What are differences between DTSC-200A and DTSC-200 ?

Clemens - 2025-08-25 - DTSC-200

DTSC-200A

DTSC-200

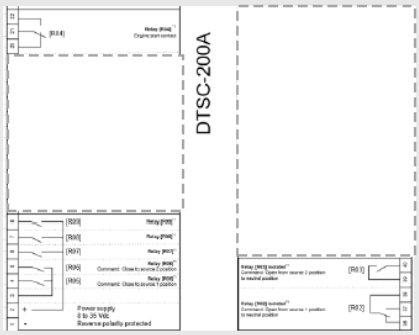
DTSC-200A	DTSC-200	Comments
Relay outputs	R01: Ready for operation relay not available. A relay can be programmed with configurable ON delay.	R01: Ready to operation tied to CPU monitoring. Programmable via LM	Overall, one less relay
Load	R02...R04 7Aac@250Vac R05, R06 2Adc@24Vdc R07...R09 3Adc@28Vdc	R01...R04 2Aac@250Vac or 2Adc@24Vdc R05...R09 10Aac@250Vac	May require additional amplifier relay
Terminal diagram

Wiring difference

Discrete inputs

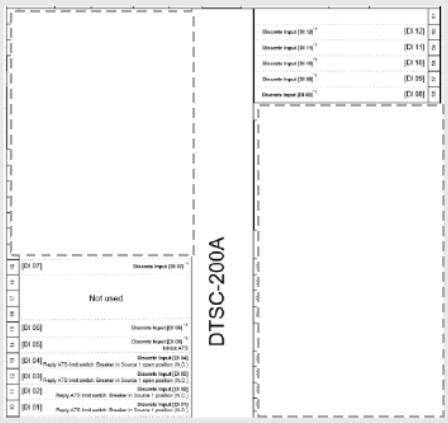
DI common connected to B-
